GNF/GEH Perspective on DG-1261, 1262, and 1263

Public Meeting on Draft Regulatory Guides

April 29-30, 2015, ORNL

Figure 4. Histogram of AOR Oxidation Results

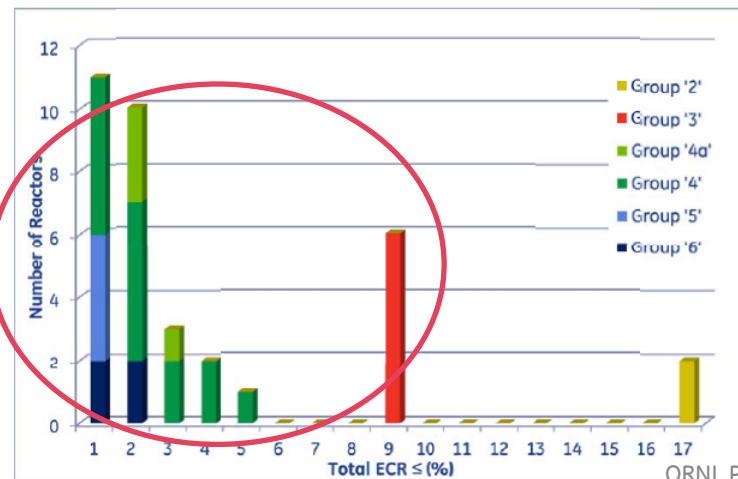
Low risk of current Zry2 used for BWR

Majority have <1000s
above 800°C
